The amendment to the specification at page 9, line 19-20, is to correct an inconsistency between the specification and the drawing of Fig. 8. Support for the amendment is found in Fig. 8.

In light of the foregoing, Applicant submits that the changes to the specification and drawings encompassed by the within amendment adds no new matter and that each proposed change is fully supported by the existing specification and drawings. Accordingly, Applicant respectfully requests that the Examiner enter the within amendments under 37 CFR 1.312(a).

Fig.3B

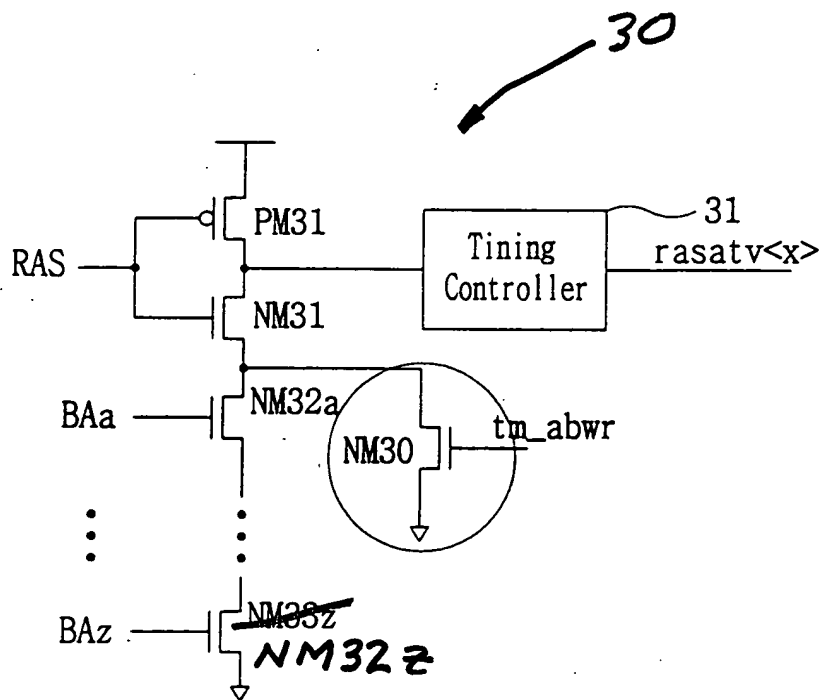
The proposed corrections to the drawing of Fig. 3B adds reference numeral --30-; and corrects a typographical error changing "NM33z" to --NM32z--. Support for the first proposed correction is found at page 6, line 20, of the specification. Support for the second proposed correction is found at page 6, line 28, of the specification.

Fig. ~~fig.~~ 4B

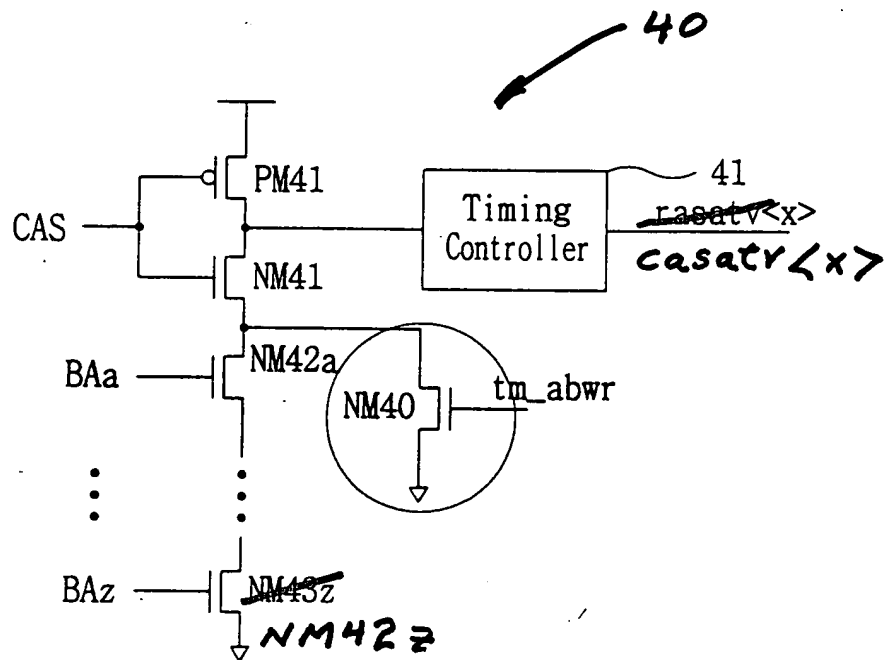
The proposed corrections to the drawing of Fig. 4B adds reference numeral --40-; and corrects a typographical error changing "NM43z" to --NM42z--. Support for the first proposed correction is found at page 7, lines 9-10, of the specification. Support for the second proposed correction is found at page 7, line 19, of the specification.

Fig. 7.

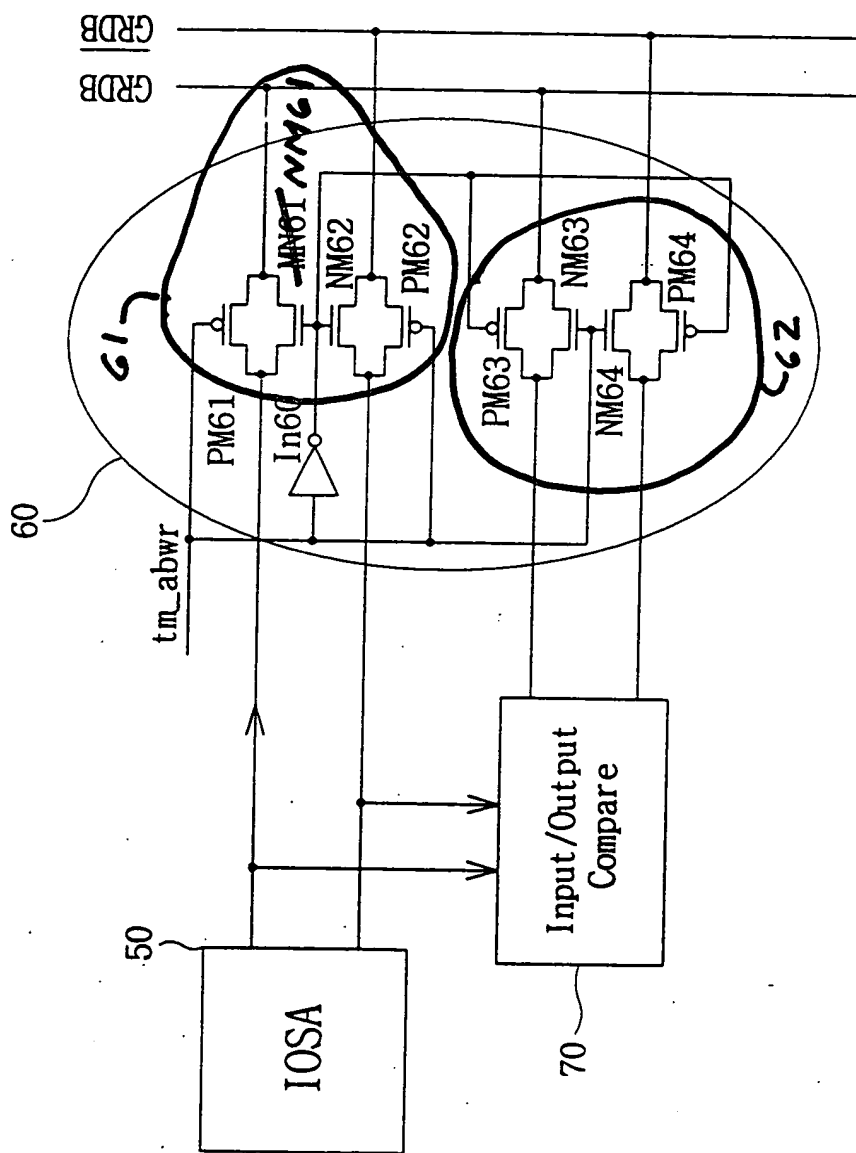
The proposed corrections to the drawing of Fig. 7 are to correct typographical errors relating to NMOS transistor NM61; and

to identify those aspects of Fig. 7 which comprise elements 61 and 62. Support for changing "MN61" to --NM61-- is found at page 8, line 18, of the specification. Support for adding reference numeral --61-- is found at page 8, line 17, through page 9, line 1, of the specification. Support for adding reference numeral --62-- is found at page 9, lines 2-15, of the specification.
